Planning Register Reference: SD22A/0371

I refer to Planning Application Register Reference **SD22A/0371** in regard to a proposed SEN unit at Scoil Naomh Aine National School, New Road, Dublin 22.

We wish to submit our compliance information in relation to the Conditions of Planning of the South Dublin County Council Grant of Permission.

Fig 1 Site Plan

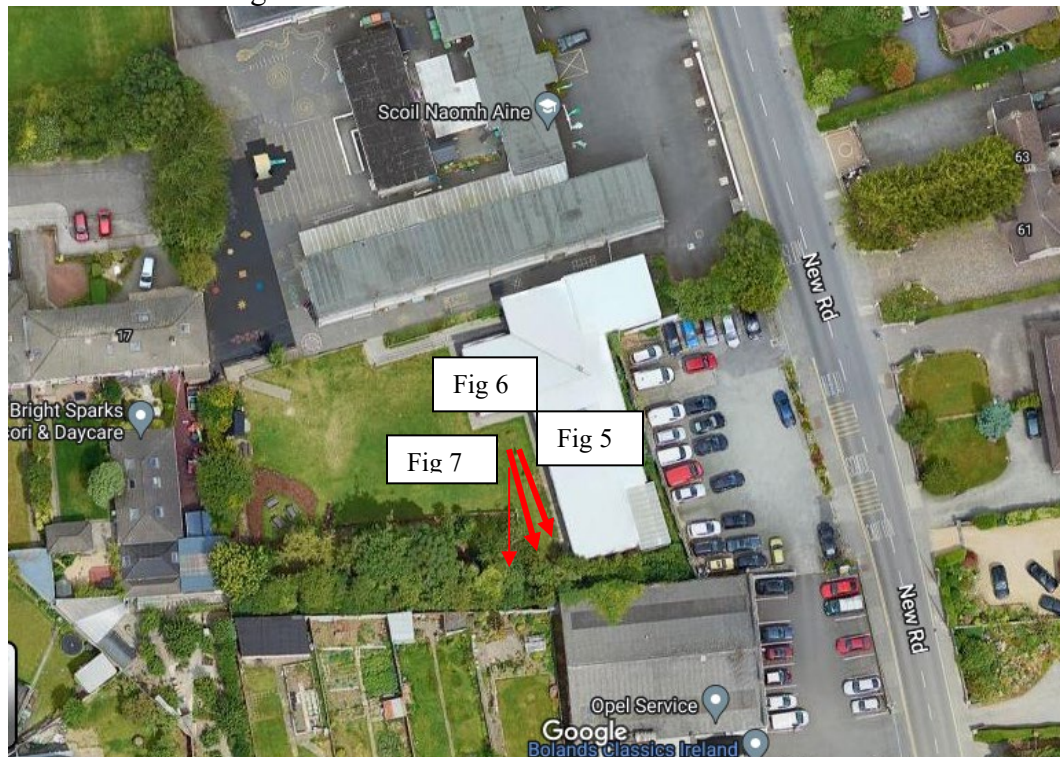
ii) ***Pre Development Photo's: Prior to the Commencement of Works the applicant shall submit pictures of the existing trees/ hedgerows before work commence with the tress protective fencing. This shall include a location map of where each picture was taken from.***

LBA Response: below is the Photos indicating the existing area prior to works commencing: We have attached a site map with the photographs displayed of each area noting.
